DESIGN	DRAWN BY <i>UP</i>	DART AEROSPACE LTD HAWKESBURY, ONTARIO, CANADA	
CHECKED	APPROVED	DRAWING NO. DSI 9262	REV. A SHEET 1 OF 1
DATE 03.05.14		TITLE SKIDTUBE REPAIR	SCALE NTS
A	03.05.14	NEW ISSUE

DART SERVICE INSTRUCTION

TO AMEND D412-673 Rev. A
AND D205-634 Rev. A OR Rev. B
REF. CANADIAN STC: SH96-88
REF. FAA STC: SR000563NY

FWD/AFT VIEW OF SKIDTUBE

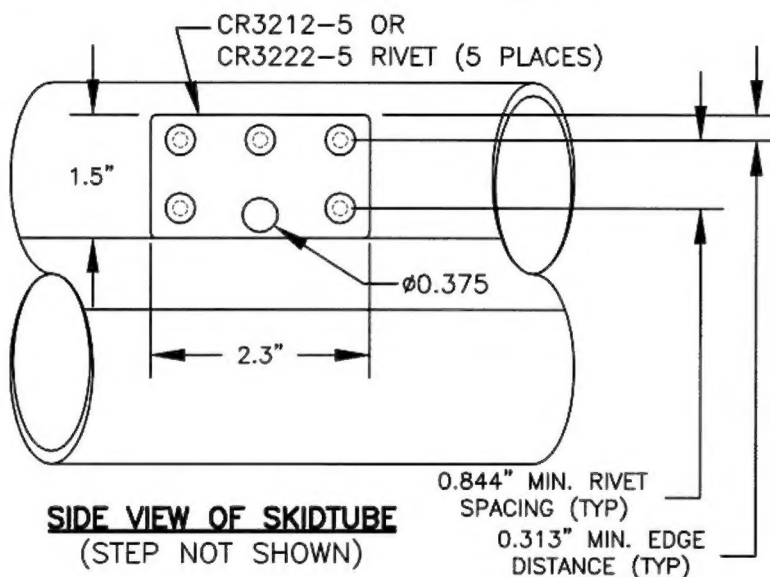
To repair elongated holes used to attach Bell electric step to Dart D205-634-011 skidtube:

- 1) Temporarily remove (4) bolts that attach electric step to Dart D205-634-011 skidtube.
- 2) Remove (4) ALS7-428-165 inserts.
- 3) Fabricate doublers from 1/4 hard 14 gauge (0.080") AISI 301/302/304/316 stainless steel per MIL-S-5059 as shown below.
- 4) Install over damaged area using CR3212-5 / CR3222-5 rivets and Proseal 890. The location of the doubler (and $\varnothing 0.375$ hole) may have to be adjusted fwd/aft to allow for fitting under the skidtube wearplates.
- 5) Reinstall electric step using hardware shown below. Transfer drill $\varnothing 0.375$ through web.

0.844" MIN. RIVET
SPACING (TYP)
0.313" MIN. EDGE
DISTANCE (TYP)

AN6-53 BOLT (1)
AN960JD616 WASHER (2)
AN310-6 NUT (1)
MS24665-285 COTTER PIN (1)
